EIR Ref 2017/023

REQUEST UNDER ENVIRONMENTAL INFORMATION (SCOTLAND) REGULATIONS 2004

From: [REDACTED]
Sent: 13 November 2014 11:23
To: planningemail
Cc: [REDACTED]
Subject: 2014/0277/DET

3. Move bench locations to avoid tree roots as shown in images below.

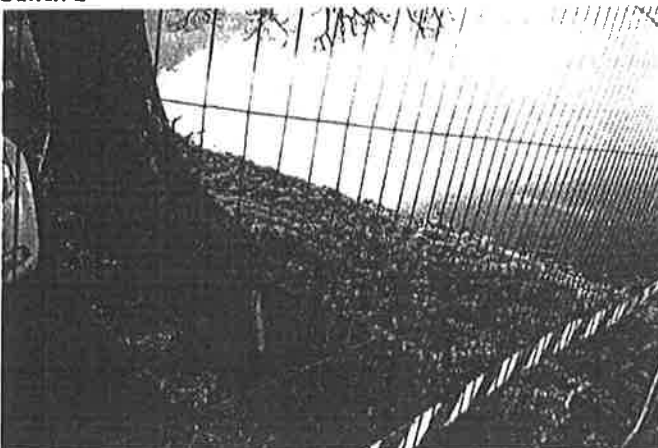
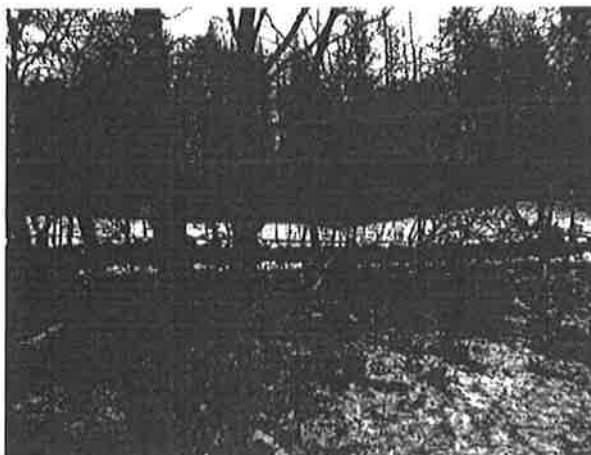
Bench 1

Bench 2

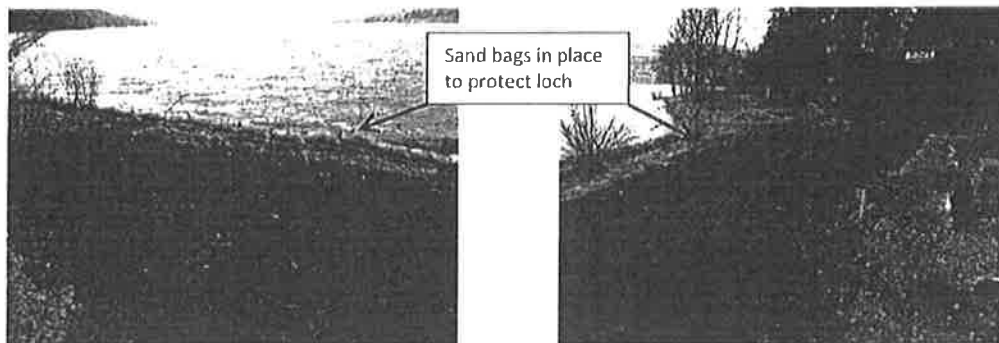
2. The location of the entrance to be moved by 2m to the left (looking towards road) to prevent cutting down alder and to avoid root plate. This required the limb of the tree on the opposite side of the access point to be cut off which had been done prior to the second ECoW visit. This avoids the need to remove the alder entirely.

Removal of stem has prevented the removal of tree on other side of access

1. Rock armour being put in place is being extended along to the tree on the left of the armour as shown in the images below:

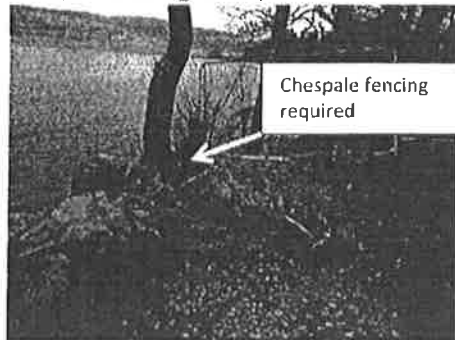
ECoW was informed that this would be completed within the next two days. Agreed that if it was to take longer, or the weather was to change to rougher conditions then sand bags would be put in place along the remaining area of 'unarmoured' section to prevent material entering loch.

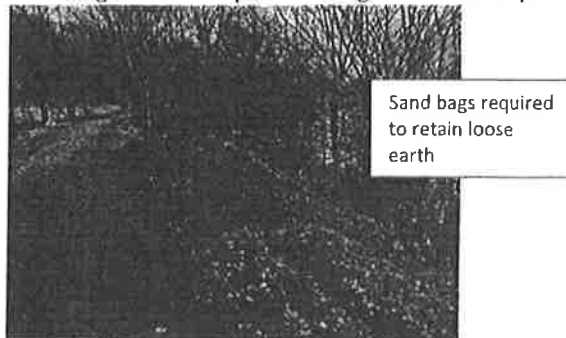
3. In agreement with the National Park Authority excavated earth has been deposited in a mound along the road site. This needs to be monitored to ensure that the loose earth does not start 'travelling' towards the loch. Action should be taken to retain the soil should it start to move towards the loch.

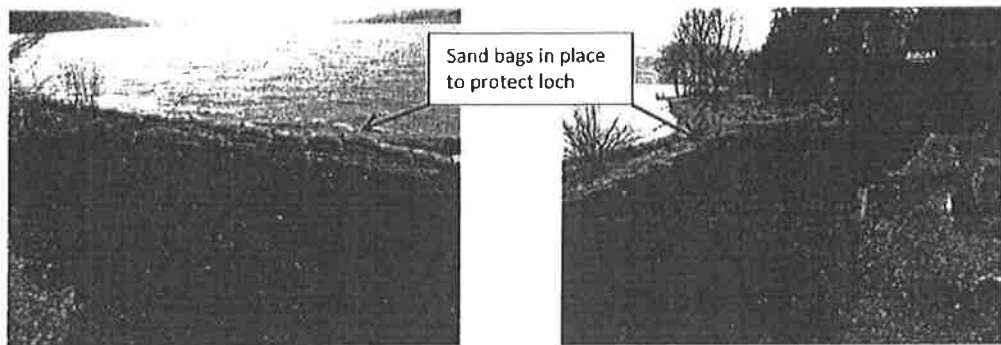
2. The location of the entrance to be moved by 2m to the left (looking towards road) to prevent cutting down alder and to avoid root plate. This required the limb of the tree on the opposite side of the access point to be cut off which had been done prior to the second ECoW visit. This avoids the need to remove the alder entirely.

Removal of stem has prevented the removal of tree on other side of access

1. Rock armour being put in place is being extended along to the tree on the left of the armour as shown in the images below:

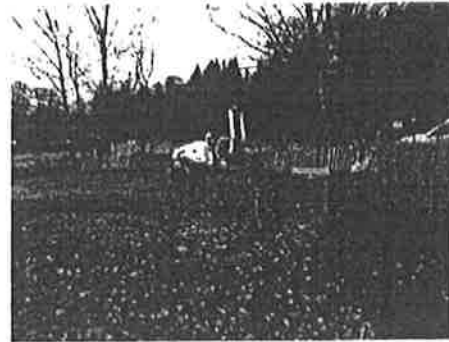
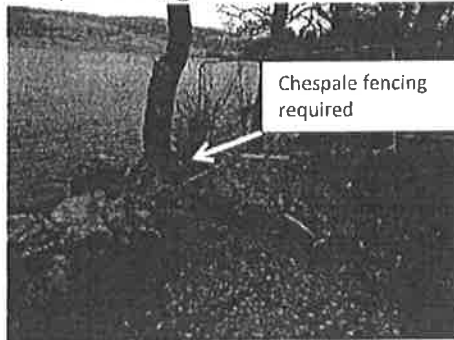
ECoW was informed that this would be completed within the next two days. Agreed that if it was to take longer, or the weather was to change to rougher conditions then sand bags would be put in place along the remaining area of 'unarmoured' section to prevent material entering loch.

5 LOCHS - VENACHAN SCOT
 HARBOUR SITE
 SITE LAYOUT.
 577/54/HARBOR.

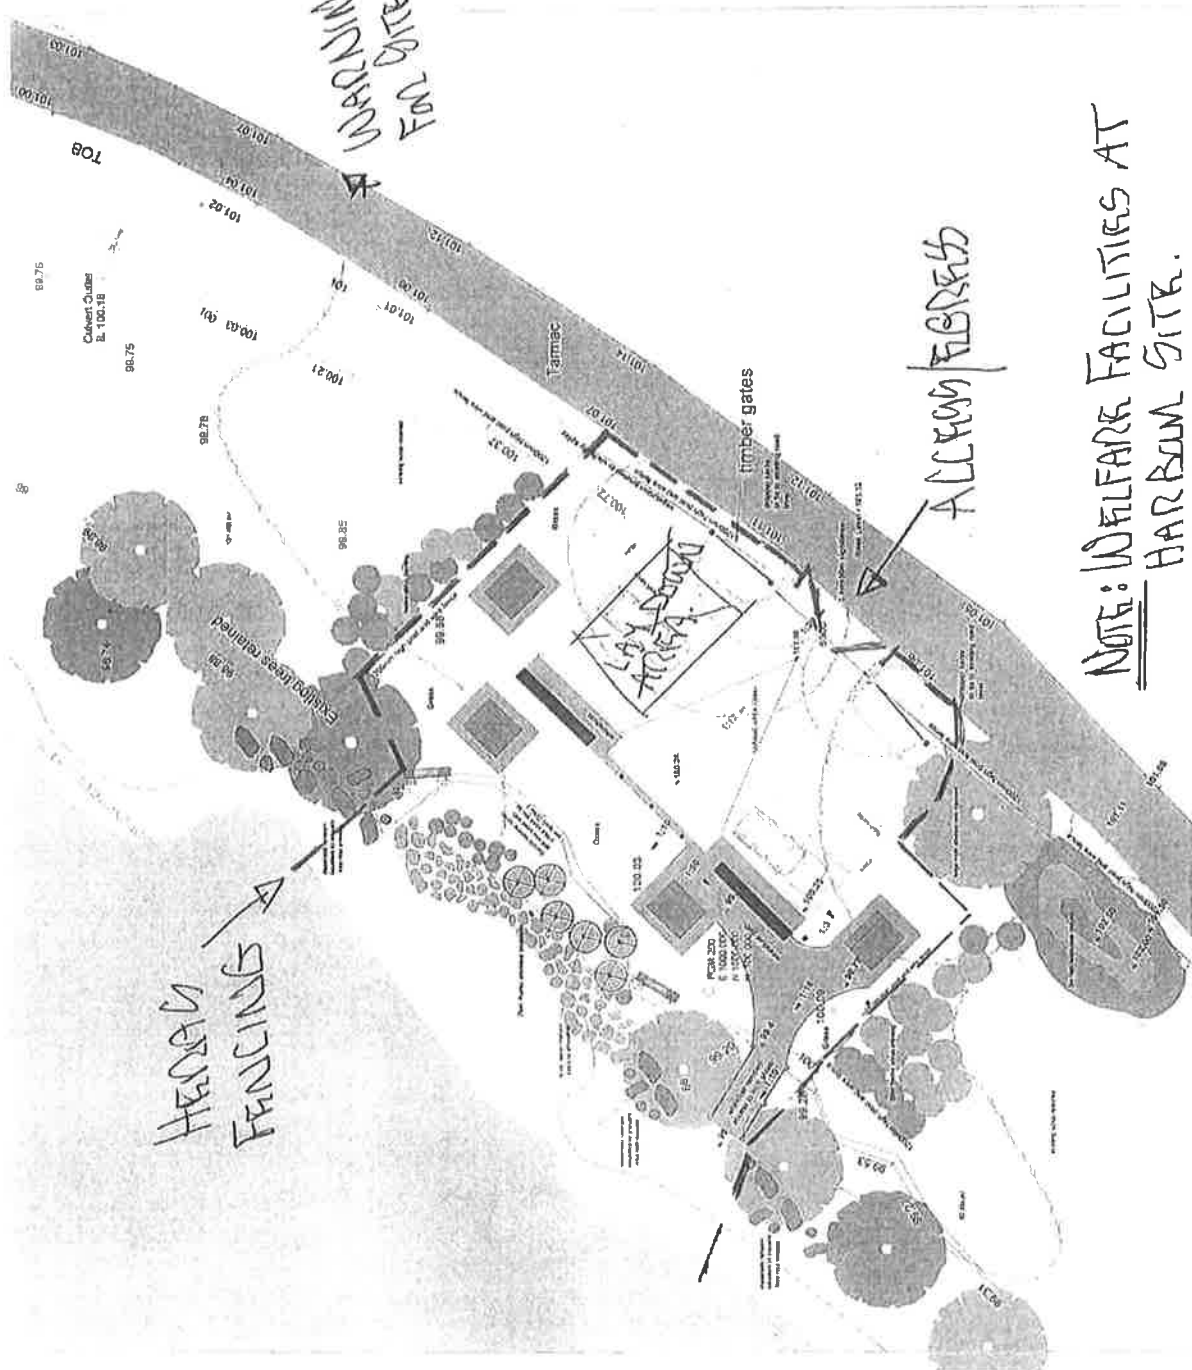
- The letter from Dermot Smyth (150126_Discharge of Conditions) confirms that machinery and equipment will not be near burns, nor cross burns.
- The Hadden Site Layout Plans 577/SK/1 and 577/SK/2 show Heras fencing **however this does not show tree protection exclusion fences**

- The site laydown areas are shown and setting out **however this does not include the large birch tree exclusion zone** on 577/sk/2 (as discussed) and in fact **the tree is not shown on the plan (left hand side of photo attached).**

- *Please find attached "Western Site Layout – Rev A" and "Harbour Site Layout – Rev A" which show the tree protection exclusion fences**
- *The site laydown areas are shown and setting out **however this does not include the large birch tree exclusion zone** on 577/sk/2 (as discussed) and in fact **the tree is not shown on the plan (left hand side of photo attached).***
